Subject: Indian Point Nuclear Generating Unit No. 3
Docket 50-286
**Request for Additional Information Regarding Steam
Generator Tube Inspection Reports for the 2003 Outage, Indian
Indian Point Nuclear Generating Unit No. 3 (TAC NO. MC1912)**

**RESPONSE TO REQUEST FOR ADDITIONAL INFORMATION REGARDING
STEAM GENERATOR TUBE INSPECTION REPORTS FOR THE 2003 OUTAGE,
INDIAN POINT NUCLEAR GENERATING UNIT NO. 3 (TAC NO. MC1912)**

**Entergy Nuclear Operations, Inc.
Indian Point Nuclear Generating Unit No. 3
Docket No. 50-286**

Figure 1
Tubesheet Map for Westinghouse Model 44F Steam Generator

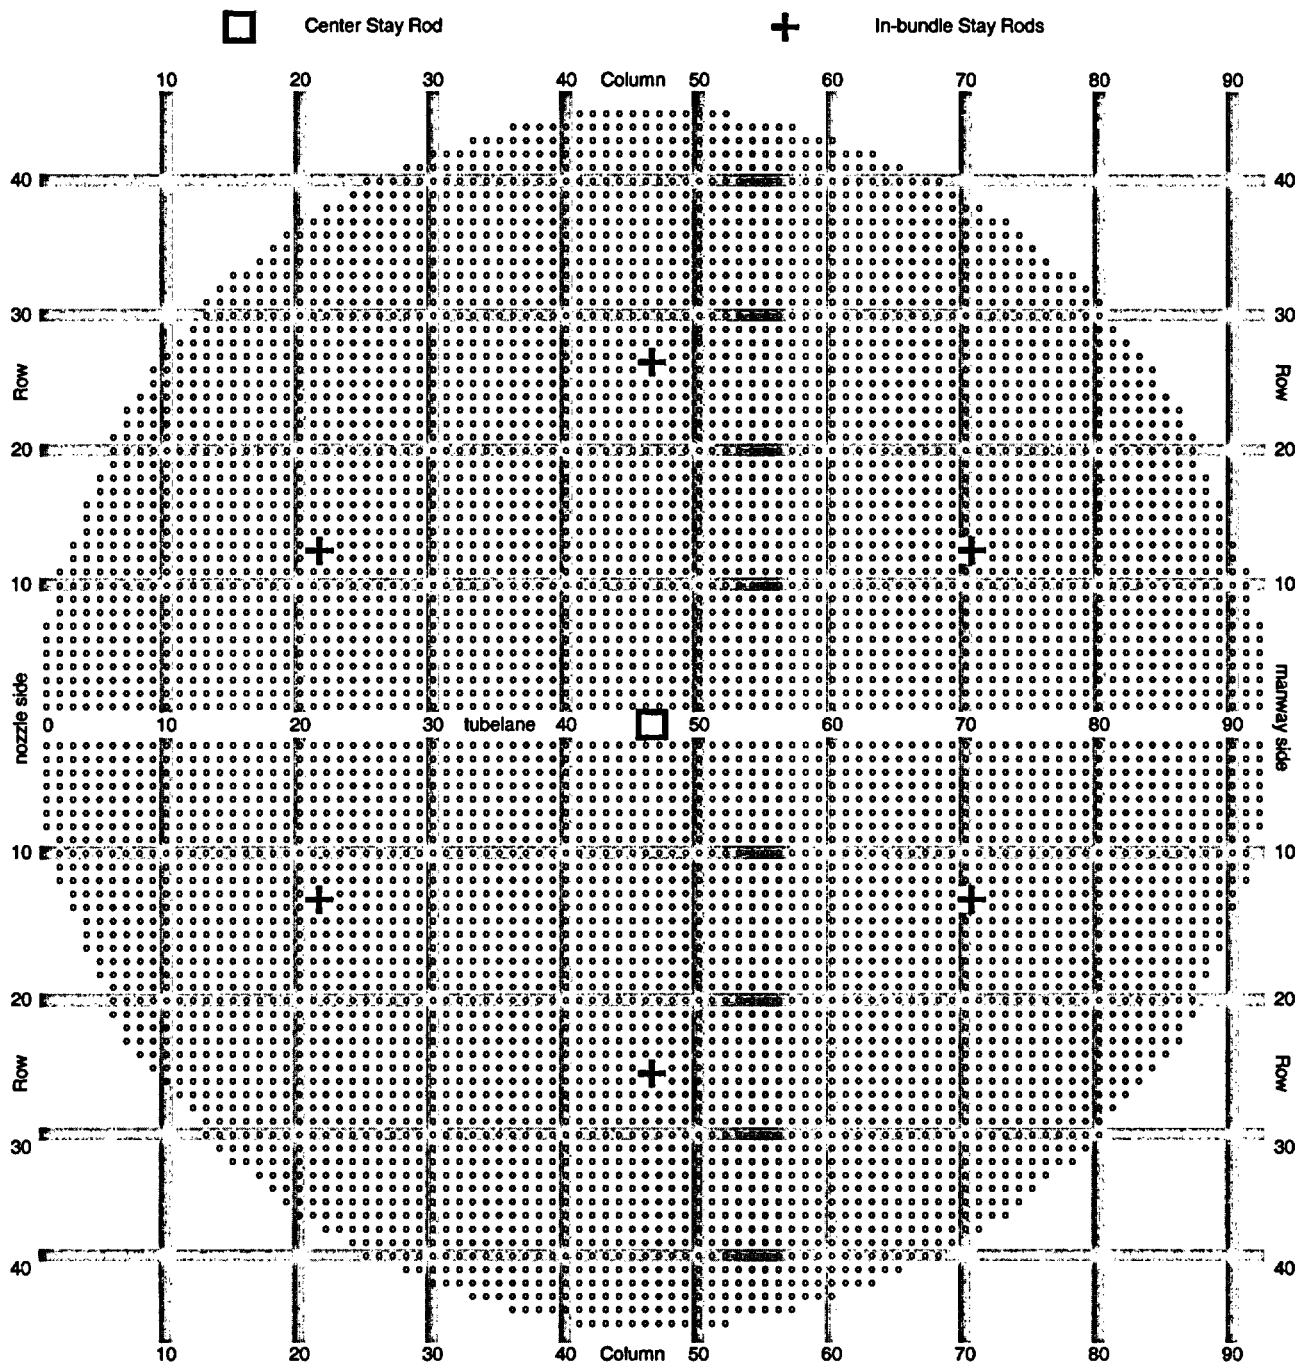
- 1) *The SGs at IP3 were replaced in 1989 with Westinghouse Model No. 44F SGs. In several locations, the reports reference tube support structures (e.g., 1C) and tube locations (e.g., Row 29, Column 17). In order for the NRC staff to better understand the location of the indications, provide a sketch of the IP3 SGs that depicts the tube and support naming conventions. In addition, provide the following general design information: (a) tube manufacturer and (b) tube support (including anti-vibration bar) thickness. Discuss reference datum for the measurements from a tube support such that it is clear whether the measurements are from the middle of the support of the edge or the support (e.g., does AV2 minus 0.6 inch specify an indication 0.6 inch from the bottom edge of the second anti vibration bar?).*

Response: Sketches of the tube locations and support structures are provided in Figures 1 and 2 respectively. (a) The manufacturer of the steam generator (SG) tubing is Sandvik. (b) The dimensions of the support structures are as follows: the flow distribution baffle is 0.75" thick, tube support plates are 1.125" thick and AVBs are 0.690" wide on the side contacting the tubes. It is important to note that the AVBs are not perpendicular to the tubing such that the contact length varies from 0.697 through >1.50 inches. All indication locations are reported relative to the centerline of the nearest support structure except for indications within and near the tubesheet. For indications within and near the tubesheet the locations are reported relative to either the tube end (TEC or TEH) or the secondary face of the tubesheet (TSC or TSH). In the example from the question, AV2 minus 0.6 inch specifies an indication 0.6 inch from the centerline of the second anti-vibration bar in the direction of AV1.
